Groundwater Knowledge and Gaps in the Queensland Murray Darling Committee Area

Border Rivers, Moonie and Lower Balonne catchments

October 2007

Report 2.2.05 October 2007 UTS QMDC
Report NCGM 2007/6b

Figure 9. Extent of the Dumaresq model (from Chen, 2002).

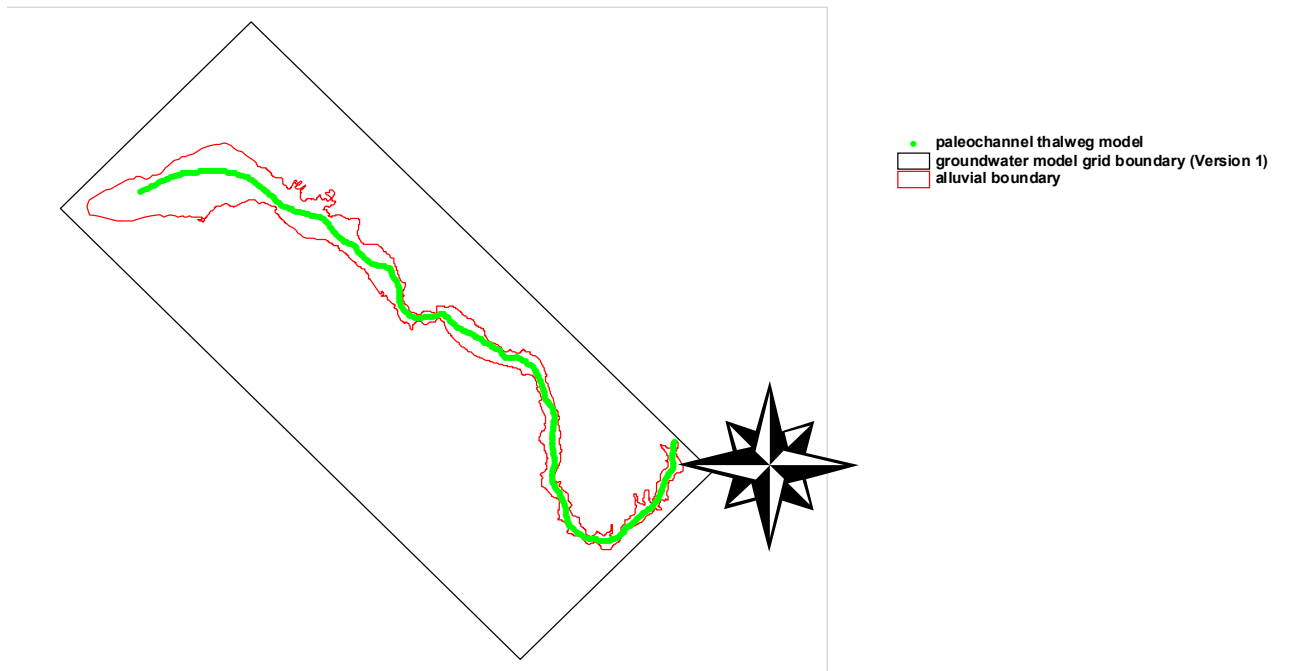
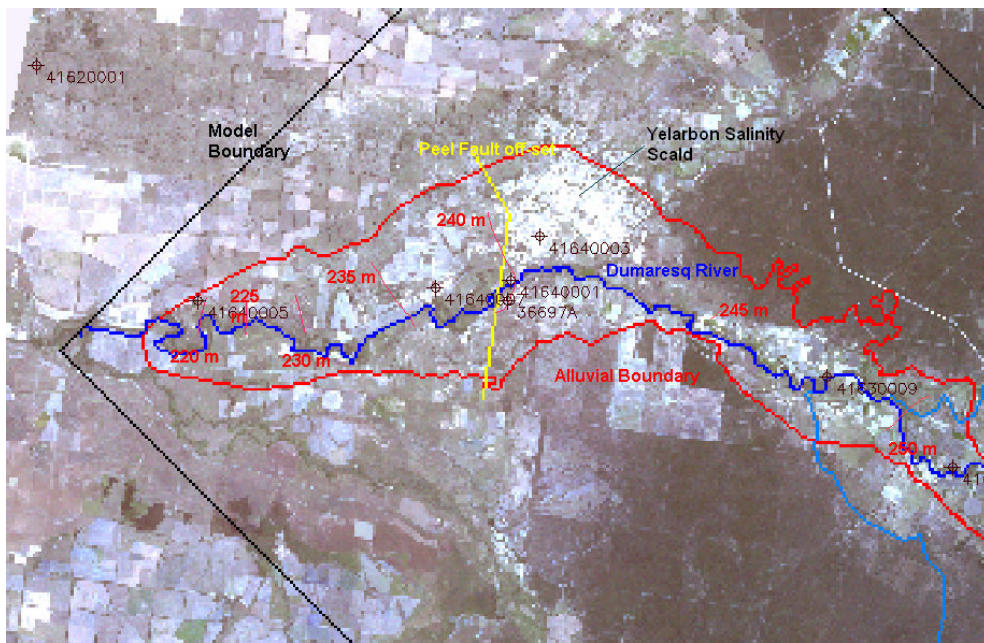
There is one feature of the model that requires improvement. The modeller elected to calculate river stages through a relationship with rainfall, rather than direct use and interpolation of real data. The reasoning for this is puzzling, particularly since the relation between river flow and rainfall has a very low coefficient of determination (0.17). This practice places a huge uncertainty on river-aquifer interactions, and this is probably the main driver of the water system. The finding of this model is that the river is mostly a gaining stream, with the river taking about one-third of natural groundwater discharge. On the contrary, Baskaran, Ransley and Brodie (personal communication) have found that the river is mostly a losing stream. Until this interaction is resolved, the findings of the model must be treated with caution.

The existing model provides a good foundation for ongoing development. What needs to be done is replacement of river stages by measured and interpolated levels, some re-calibration, then validation using the 2000-2005 data set. One limitation of the modelling that can't readily be addressed is that groundwater pumping data per bore is available only annually, whereas monthly volumes are required for proper calibration. It is imperative that bore pumping be monitored on a monthly time scale.

As the main cotton-growing area lies farther to the west, the model area should be extended in this direction, or a separate model should be developed along the MacIntyre River. The model developed by Whiting (2007) is a step in this direction.

4.0	5.2.1. MODEL DESIGN								
4.1	Is the spatial extent of the model appropriate?			No	Maybe	Yes			Excludes main cotton growing area downstream.
4.2	Are the applied boundary conditions plausible and unrestrictive?		Missing	Deficient	Adequate	Very Good			Should use real river stages, not estimates derived from rain.
